# SERVICE BULLETIN

## Service Bulletin No. 075

### Alternator Drive Coupling Inspection

**Table 2 - Materials Required**

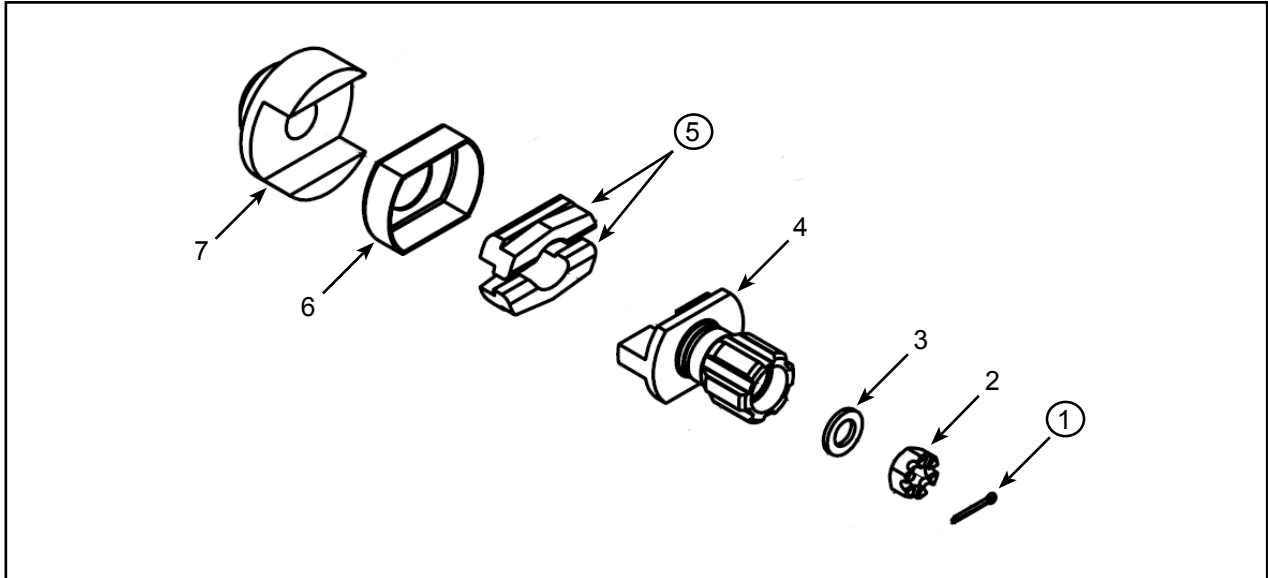
**NOTE 1:** Circled Item Numbers are required replacement parts per affected alternator.

**NOTE 2:** ▲ On-condition items. Replace if worn or damaged.

Figures 1 & 2 - Alignment Inspection

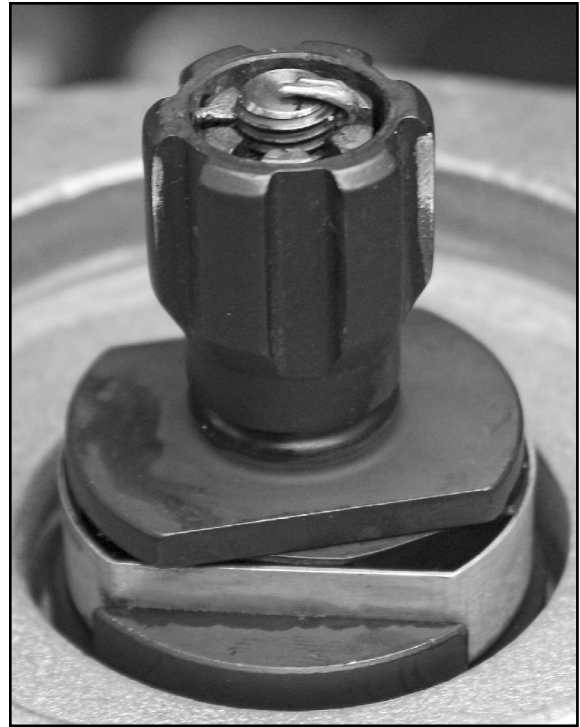
- (3) If the alternator serial number is affected per section 1.A:
  - (a) Utilize applicable aircraft maintenance manual to remove the alternator and inspect the alternator gear drive (Item Number 4, Table 2 – Materials Required) for correct alignment. Refer to Figures 1 & 2 - Alignment Inspection.

- 1) If **INCORRECT** alternator gear drive alignment is observed, continue to Corrective Action section 3.B.(1).
    - 2) If **CORRECT** alignment is observed, the affected alternator may be re-installed on aircraft and re-inspected in accordance with section 3.A.(3) every fifty (50) hours time-in-service until a total of two hundred and fifty (250) hours time-in-service is reached from release date of this SB.

- a) When a total of 250 hours time-in-service is reached from the release date of this SB, continue to Corrective Action section 3.B.(1) of this SB regardless of inspection findings.

Figure 3 - Tool Fabrication Design

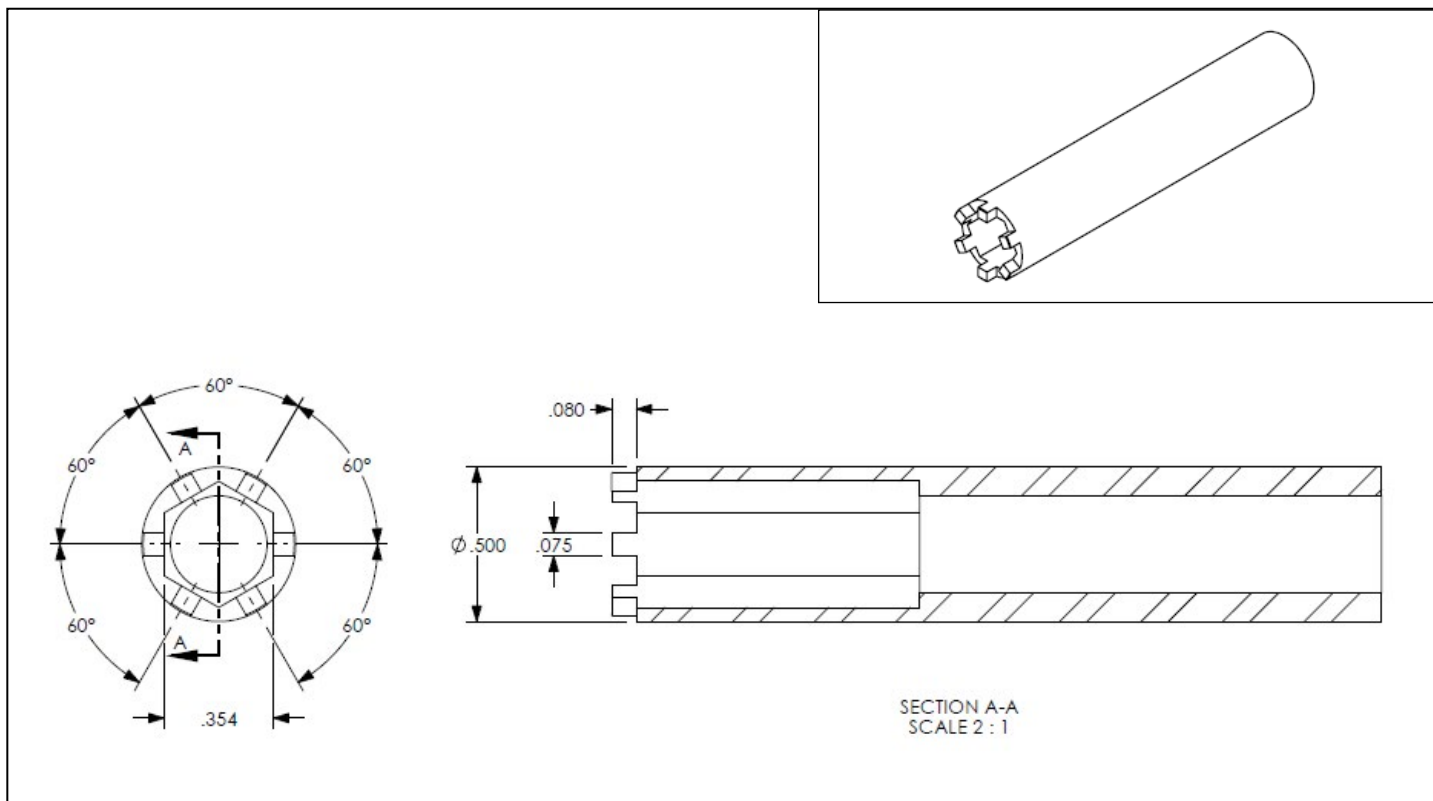
2) Reference Figure 3 to fabricate a tool that will interface with nut castellations and remove Nut (2) from the gear shaft. Retain nut (2) and washer (3) for assembly.
